**To:** Tony Andary                      Andarys Enterprise, Inc                      aandary@sbcglobal.net  
**From:** William Rosentel                      Mei Wu Acoustics                      william@mei-wu.com  
           Mei Wu                                      Mei Wu Acoustics                      meiwu@mei-wu.com  
**Date:** October 23, 2017  
**Subject:** Andoil Bascom Car Wash - Peer Review Response  
                   MWA Project – 15059B

MWA completed an environmental noise study for the Andoil Bascom Car wash dated December 20, 2016. A peer review of that study has been completed by Illingworth & Rodkin (I&R) dated October 11, 2017. This document is a response to that peer review, intended to address the specific comments provided by I&R.

**Figure 1:** Range of Carwash Exit Noise Levels Relative to the RYKO 3 (Range provided by I&R)

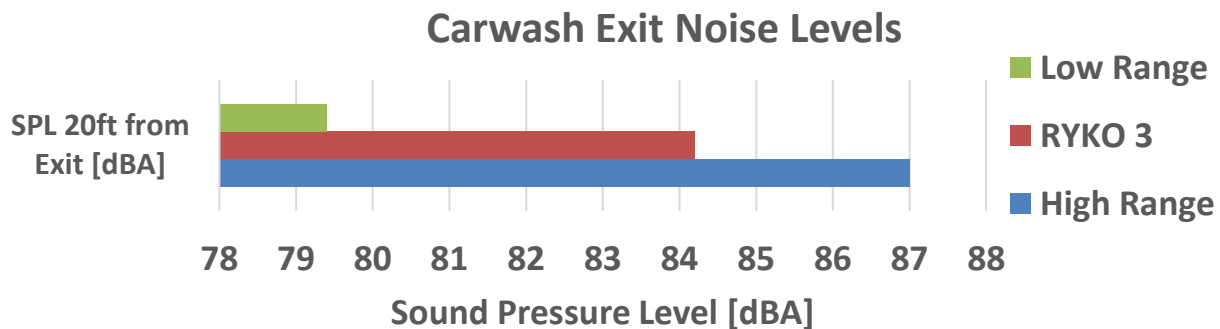
The I&R peer review correctly points out that the noise levels used in the original study are based on the noise levels of carwashes observed in previous projects. I&R has also conducted carwash noise studies, and provide a range of noise levels at 20 feet from the exit of 79.4 dBA to 87.0 dBA. The carwash noise levels referenced in the original study are for the RYKO 3-Fan Slimline Dryer; which has a level of 84.2 dBA measured 20 feet from the exit (see Figure 1).

The noise level of the RYKO 3-Fan Slimline Dryer is in the upper half of the range suggested by I&R. The RYKO 3 noise level may be considered an upper ceiling that the actual selected dryer must not exceed.

**The selected dryer will be accompanied by manufacturer published noise data that does not exceed the RYKO 3 sound levels. This may be verified via review of the manufacturer submitted noise data by a qualified acoustical consultant.**
